## Product Change Notification / SYST-05VUWX019

ERRATA - SAM D09 Family Silicon Errata and Data Sheet Clarification

## SAM D09 Series Family Silicon Errata and Data Sheet Clarification

**FIGURE 30-2: POR OPERATING PRINCIPLE:**

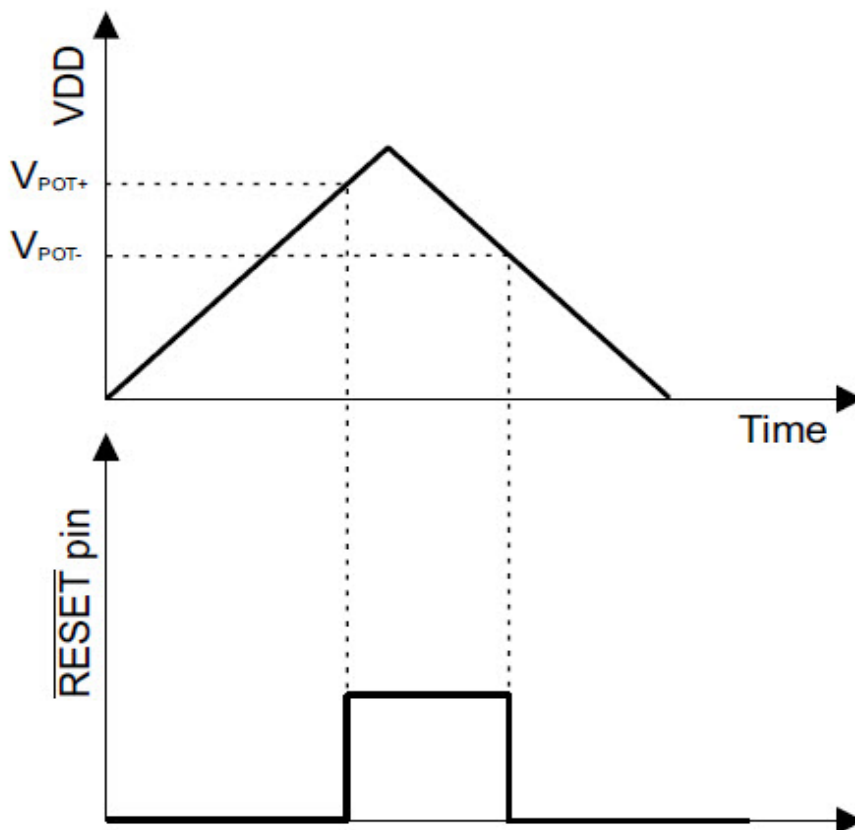
Figure 30-2, 30-3, and Figure 30-4 have an incorrect reset Polarity value. The corrected figures are as shown below:
